Access Compliance Report

Public Rights-of-Way

Intersection ID: 2789	Main Street: MARSHBANK_LN	Cross Street: RIDGEFIELD_DR	Location: NW
ADA ID: D7AD6B2F322D	Ramp Type: BlendTrans1	Initial Pass/Fail: Fail	Overall Compliance: No
		Severity Score: 8.75

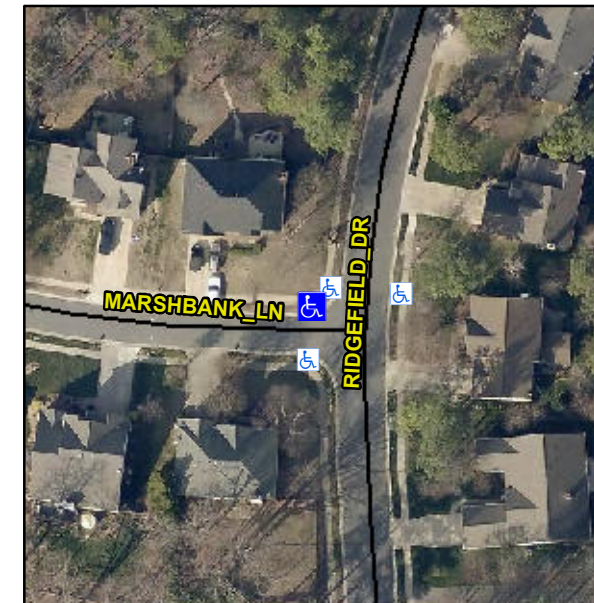
Compliance	Description	Data	Compliance	Description	Data
N/A	Ramp Length (in)	48.0	Yes	BlendTrans Slope (%)	3.5
No	Ramp Width (in)	38.0	Yes	BlendTrans XSlope (%)	0.3
N/A	Flare Type LT	N/A	N/A	Flare Type RT	N/A
N/A	Flare Slope LT (%)	N/A	N/A	Flare Slope RT (%)	N/A
N/A	Flare Traversable LT?	N/A	N/A	Flare Traversable RT?	N/A
N/A	Landing Length (in)	N/A	N/A	DWS Provided?	N/A
N/A	Landing Width (in)	N/A	N/A	DWS Contrast?	N/A
N/A	Landing Slope (%)	N/A	N/A	DWS Length (in)	N/A
N/A	Landing X Slope (%)	N/A	N/A	DWS Full Width?	N/A
N/A	Landing Curb? (Y/N)	N/A	N/A	DWS Offset (in)	N/A
N/A	Shared Landing?	N/A			
N/A	Gutter Ponding?	N/A	N/A	Gutter Slope (%)	N/A
N/A	Gutter Lip Ht (in)	N/A	N/A	Gutter X Slope (%)	N/A
N/A	Painted X Walk1?	No	N/A	Painted X Walk2?	N/A
	X Walk 1 Direction	To S		X Walk 2 Direction	N/A
	X Walk 1 Width (in)	N/A		X Walk 2 Width (in)	N/A
	X Walk 1 Slope (%)	3.2		X Walk 2 Slope (%)	N/A
	X Walk 1 X Slope (%)	3.3		X Walk 2 X Slope (%)	N/A

N/A	Ramp inside XWalk1?	N/A	N/A	Ramp inside XWalk2?	N/A
	Road Slope (%)	3.3		Clear Space?	N/A
	Road X Slope (%)	3.2	N/A	Clear Space to XWalk (in)	N/A
N/A	Any Obstructions?	N/A	N/A	Storm Grate/Utility Hazard?	N/A
	Obstruction Type			Storm Grate/Utility Type	
		N/A			N/A
			Yes	Surface Condition? (G/P)	Good
			N/A	Curb Slope (%)	2.8

Remove & Replace Curb Ramp With Two New Directional Ramps or Equivalent.

R304.5.1
